Title: Reply LS on 'CIPHERING OF ACCESS BURSTS ON VGCS CHANNEL'
Response to: LS S3-050023 (GP-050599) 'CIPHERING OF ACCESS BURSTS ON VGCS CHANNEL'
Release: Rel-6
Work Item: VGCS

Source: SA3
To: GERAN2
Cc: ----

Source: Siemens
Title: Access burst ciphering for VGCS
Agenda item: VGCS
Document for: Discussion/Decision

Figure 1: VGCS uplink channel access flow

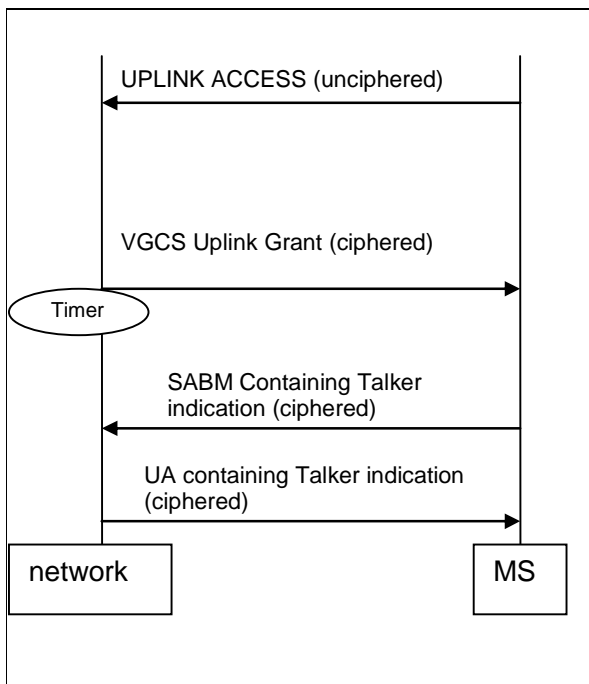
The concern that was raised during GERAN#23 is that an unciphered (i.e. not 'implicitly' authenticated by the VGCS group key) VGCS access burst for uplink access could be a potential tool for a VGCS DoS attack. An attacker (not belonging to the VGCS group) would set the emergency talker bit (a Rel-7 enhancement) within the VGCS access burst for uplink access (See Figure 1 flow), in order to try to obtain uplink channel.

However as the VGCS Uplink Grant message (which is sent back from the network to the MS) is ciphered using the VGCS group key, and the expected message back (Talker indication) are both ciphered, the attacker will not be able to grab the uplink channel (so respond successfully to the network). A couple of retransmissions of the ciphered uplink grant access message may take place. The introduced delay is dependent on the network configuration (timer value and maximum number of retransmission (Timer T3115- See Annex for a detailed description)).
